**REPORT  
INDEPENDENT HYDROLOGIST REVIEW  
ALTAROCK ENERGY  
EGS DEMONSTRATION PROJECT  
NEWBERRY, OREGON**

**February 24, 2011**

**Subject: Independent Hydrologist Review Report  
AltaRock Energy  
EGS Demonstration Project  
Newberry, Oregon**

PROJECT NO.	116075	PROJECT AREA MAP	FIGURE
DRAWN:	02/11		
DRAWN BY:	TLK		
CHECKED BY:	PS	INDEPENDENT HYDROLOGIST REVIEW EGS DEMONSTRATION PROJECT NEWBERRY, OREGON	1
FILE NAME:	116075F1.dwg

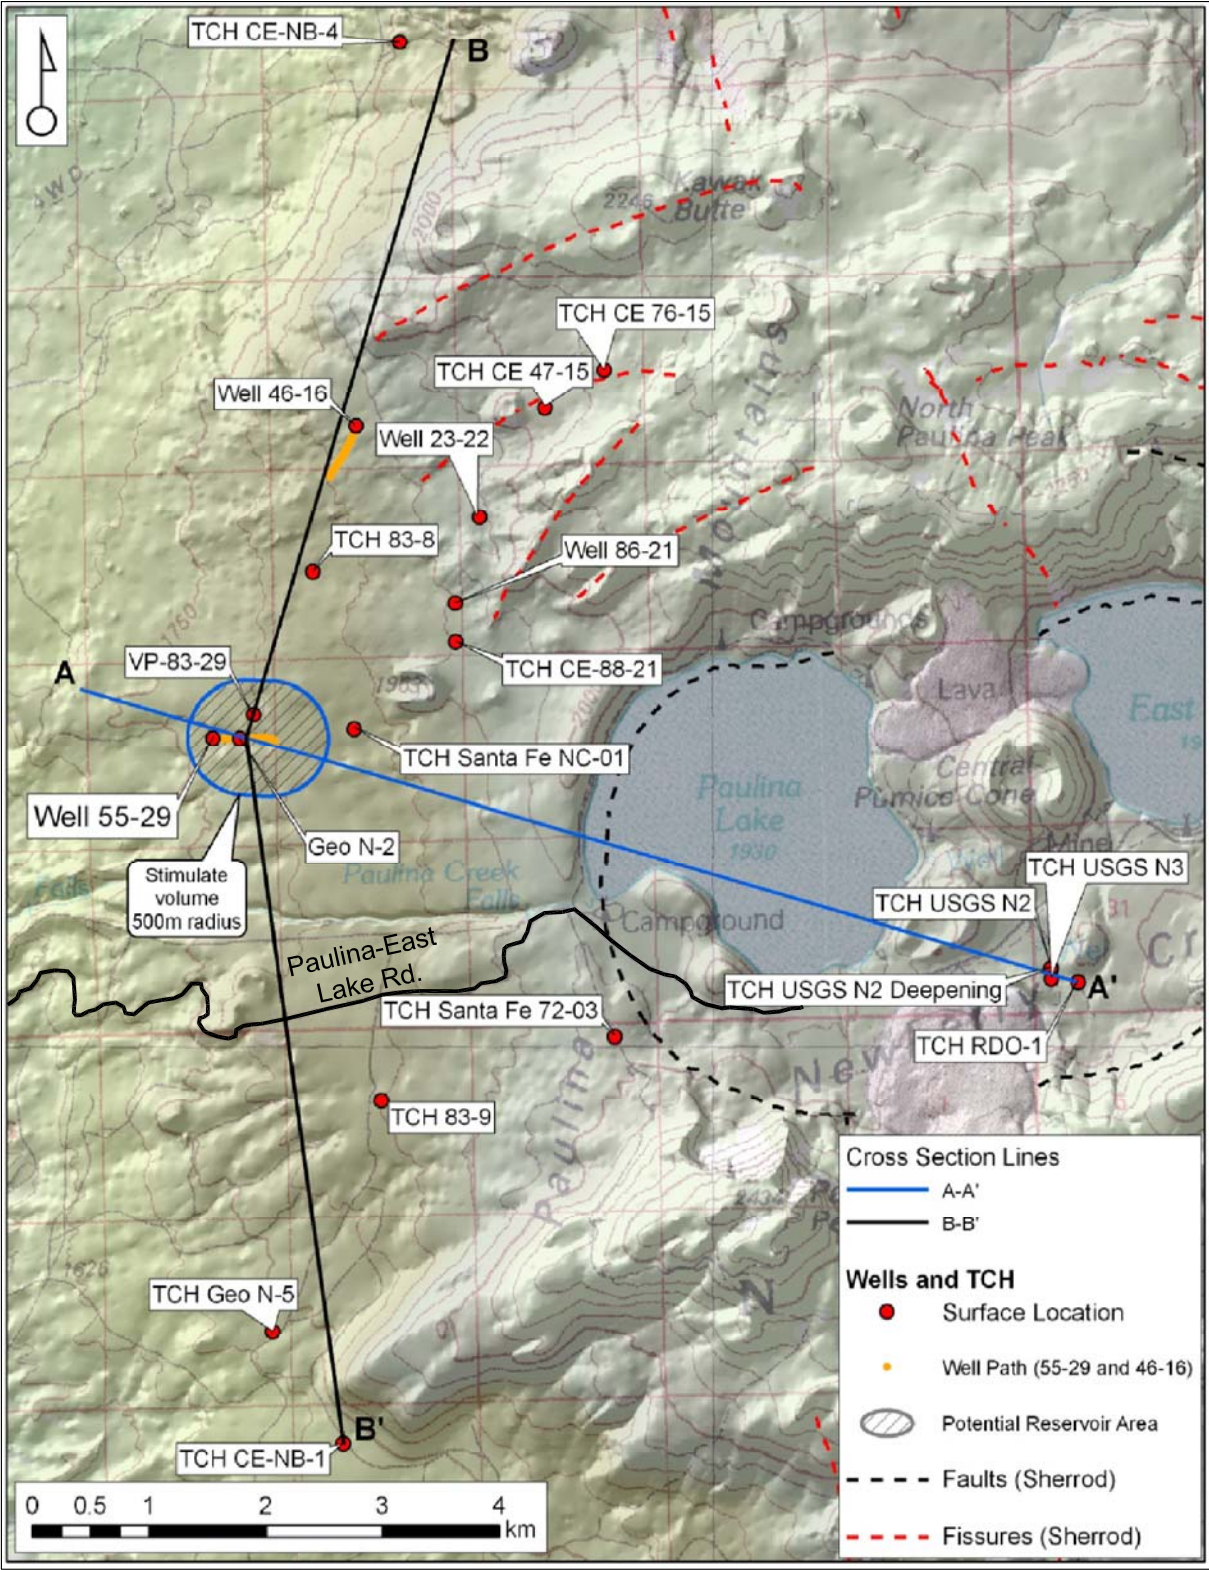
above the Paulina-East Lake Road crossing at RM 5.2 (Figure 1), the stream loses approximately 0.75 cfs/mile to groundwater (Morgan and others, 1997). Current aquifer testing in the project vicinity (Schwartz and others, 2010) indicates a relatively low transmissivity aquifer which would indicate a relative steep cone of depression around the water supply well and a small (less than 2,500 feet) radius of influence (amount of water level drawdown as one moves away from the well). These conditions further imply that the pumping of the water supply well on Pad 29 will not impact flows in Paulina Creek.

Neither of these lakes is in danger of being impacted by the demonstration project. Paulina Lake is over 2 miles from the test Pad 29 location and East Lake is even farther away. The project site aquifer being used for water supply for the test is separated from the caldera lakes aquifer by geologic structures that impede the lateral and vertical flow of groundwater. The bottom of Paulina Lake is also over 2-miles horizontal distance and over 1-mile vertical distance from the EGS stimulation zone (Figure 1).

Paulina Creek, at the crossing of County Highway 21 (also known as Paulina-East Lake Road and U.S. Forest Service Road 21) at RM 5.2, has been monitored by the US Geological Survey (Morgan and others, 1997) (Figure 1). The hydrologic flow patterns into Paulina Lake and its connection to the project site aquifer have been discussed in several of the responses provided above. We do not believe there is a need for monitoring of water flow/quality downgradient of the site at surface water bodies.

PROJECT NO.	116075	CROSS SECTION A-A'	FIGURE
DRAWN:	02/11		
DRAWN BY:	TLK		
CHECKED BY:	PS	INDEPENDENT HYDROLOGIST REVIEW EGS DEMONSTRATION PROJECT NEWBERRY, OREGON	3
FILE NAME:	116075F3.dwg

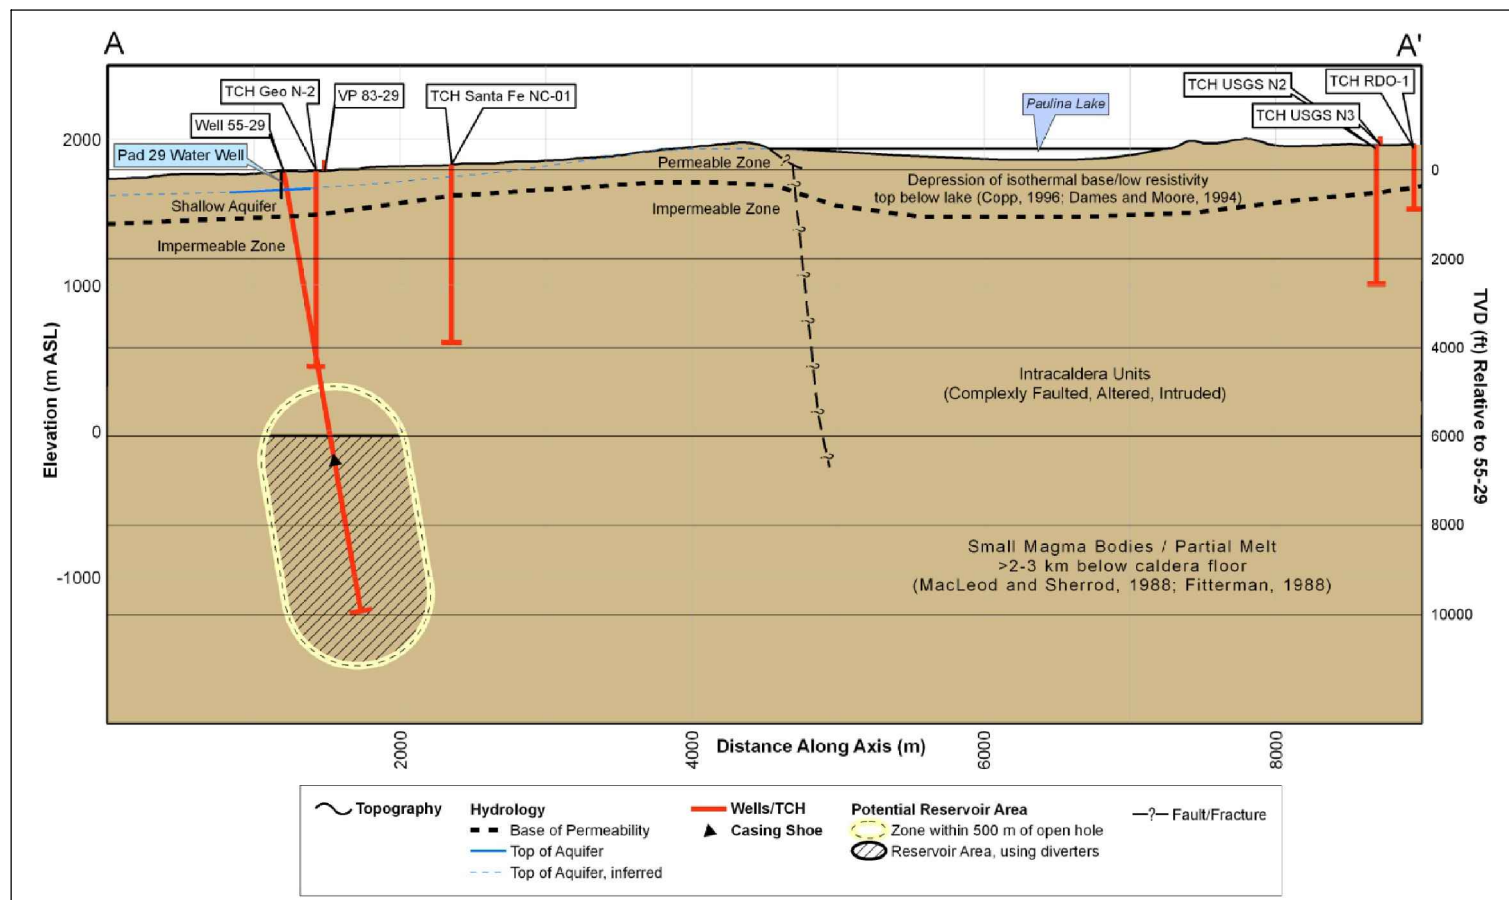
The aquifer within Newberry Caldera is recharged from precipitation and snow melt. Paulina and East Lakes are situated on both a topographic and hydrologic high meaning that water flows from these areas down to surrounding areas including the water supply well on Pad 29. The withdrawal of water from the water supply wells on Pad 29 or Pad 16 cannot affect the flow of water from the lakes since the lakes are hydrologically upgradient of these wells (Figures 2, 3, and 4).

2010) provides a summary of the hydrogeologic environment at the proposed test site (Figures 2, 3, and 4). This document along with several others we reviewed (see References section) show the base of the regional aquifer system is approximately 5,000 feet above the top of the proposed EGS reservoir zone. The estimated EGS reservoir created through hydraulic stimulation at the Pad 29 site will be a network of fractures extending approximately 1,500 feet radially. Even if these fractures extended upward from the top of the EGS reservoir zone, it would still be several thousand feet below the bottom of the project site aquifer. Given the very low permeability of the receptor rock throughout the length of the vertical borehole below the project site aquifer, it is unlikely that fluids would be able to migrate vertically during the testing period.

The estimated horizontal distance from the water supply well at Pad 29 to Paulina Creek is 4,790 feet or just less than 1 mile. The conceptual hydrogeologic model for the shallow aquifer (Figures 2 and 4) indicates that Paulina Creek is in direct connection
